ALL CONSTRUCTION GROUP

ADDENDUM NO.: 01
PROJECT NAME: North Park Village (NPV) Administration-Building C (Bid Package 1 – Campus Signage)
PROJECT NO.: 04038
DATE OF ISSUE: 6/8/2023

NOTICE OF CHANGES, MODIFICATIONS, OR CLARIFICATIONS TO CONTRACT DOCUMENTS

CAMPUS SIGNAGE PACKAGE ADDENDUM #1 2023.06.07

CAMPUS SIGNAGE PLAN

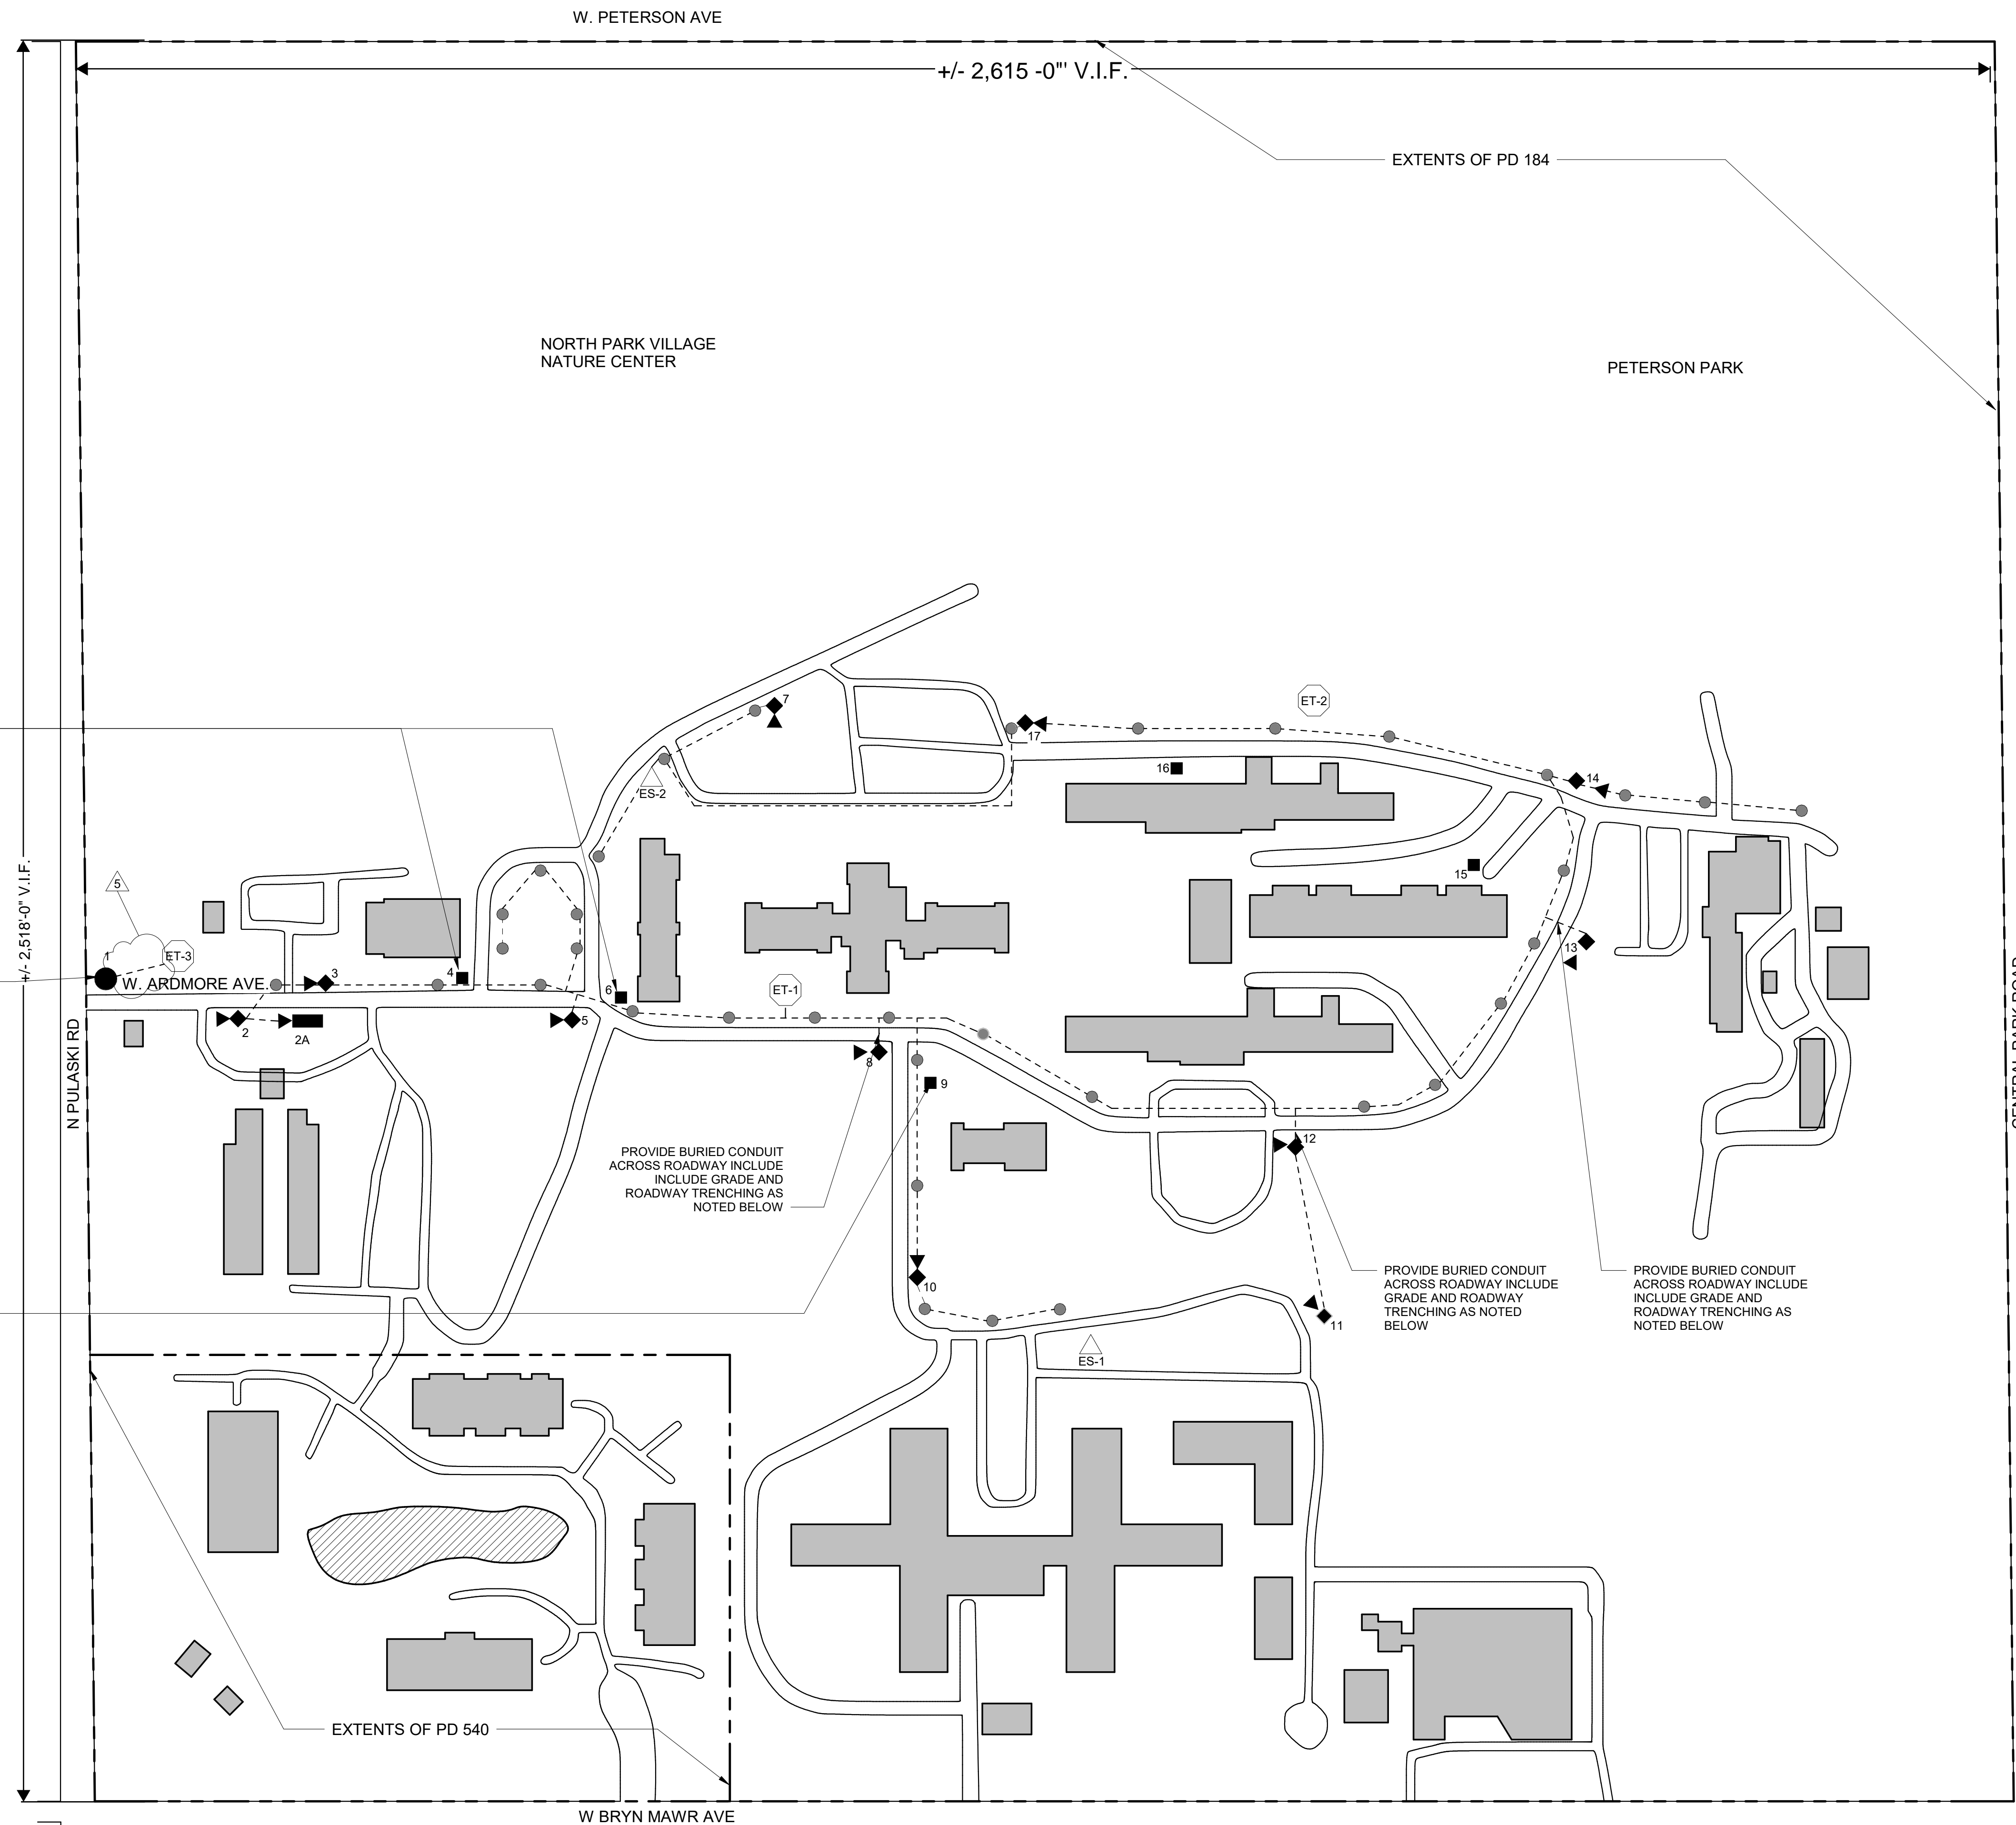
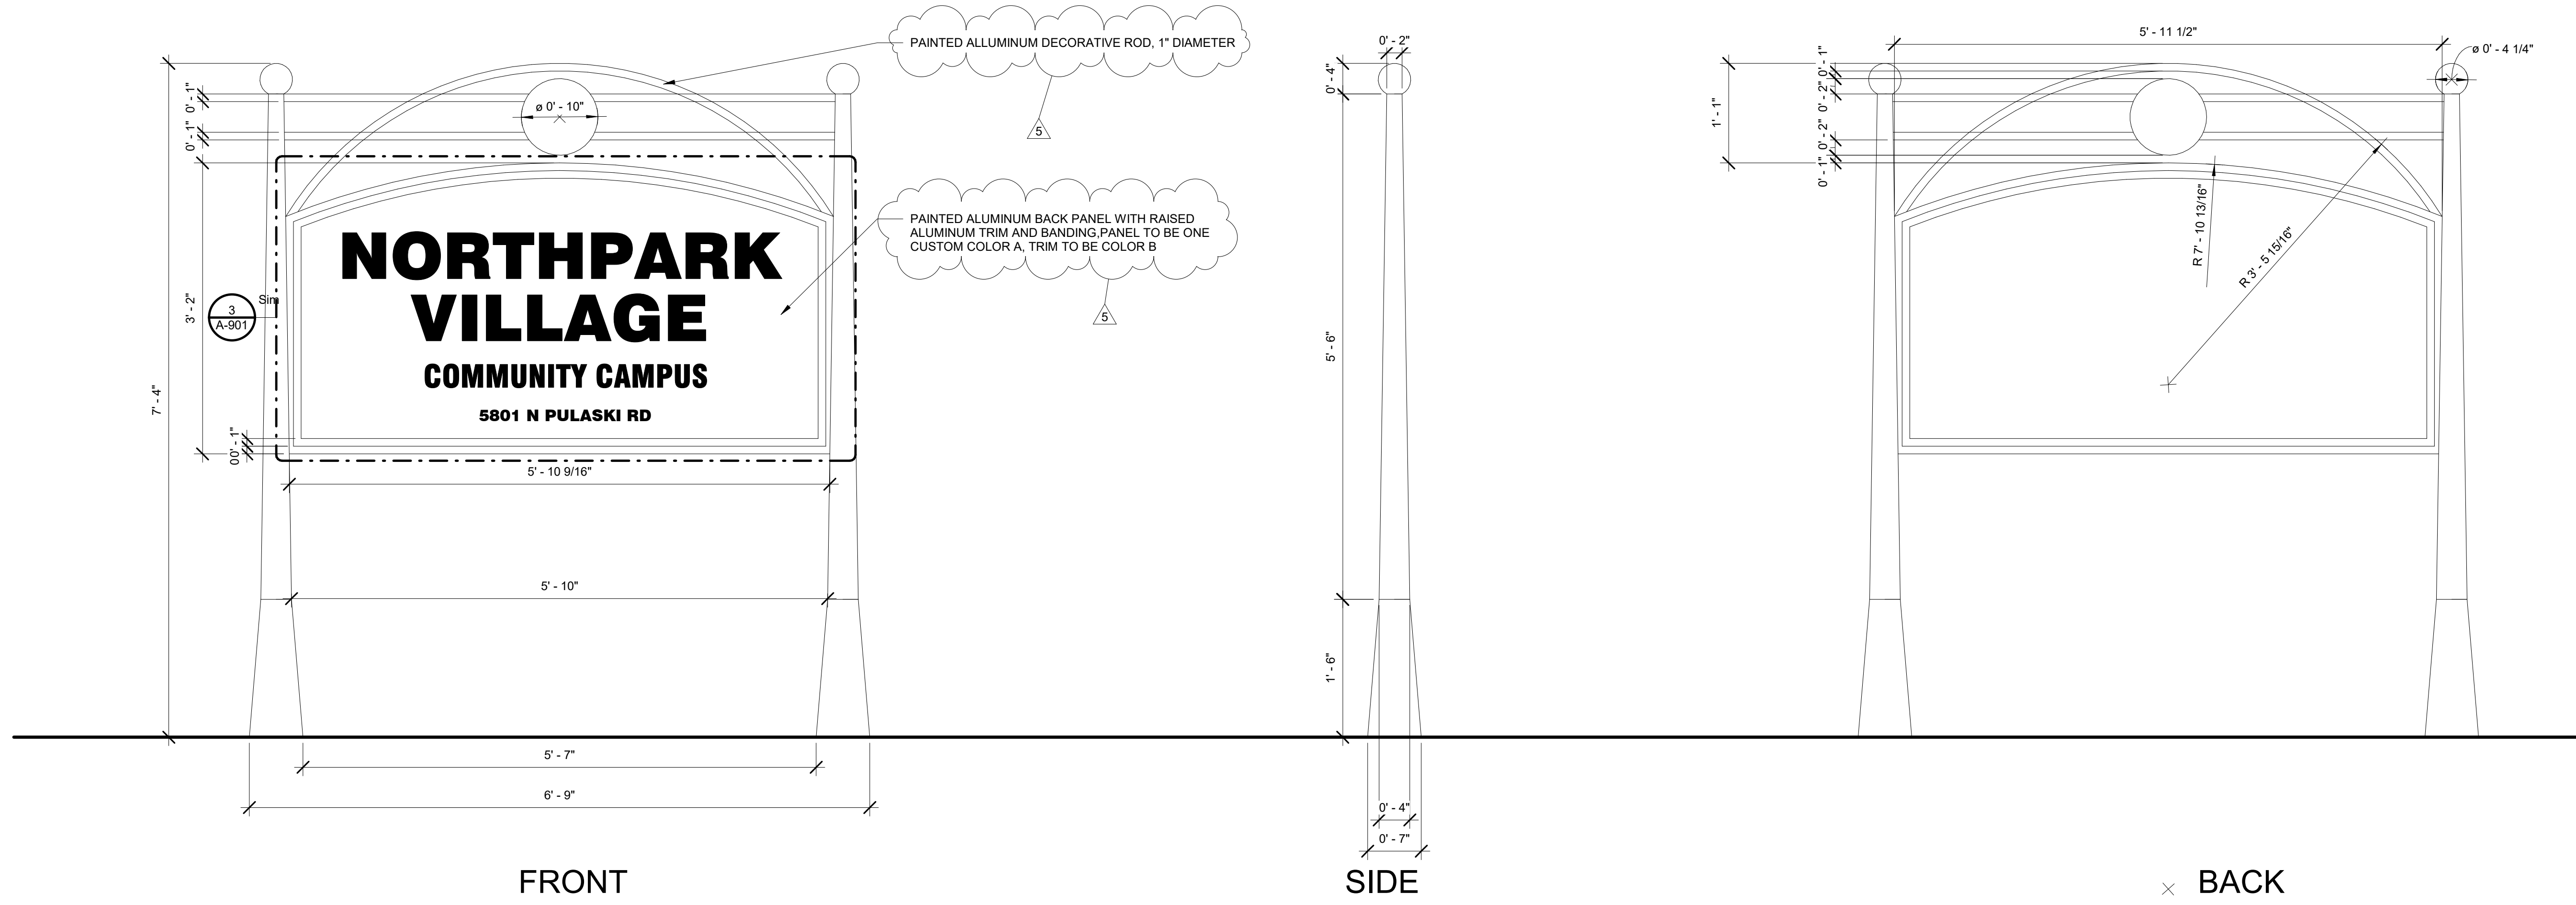
Change 2 **Revised** A-900 General Notes as follows – added note 6A –Submittals to include full size letter sample, added note 6A –Shop Drawings to be provided for each building and wayfinding sign, revised note 7 –Typographical Error, added Notes 11 and 12.
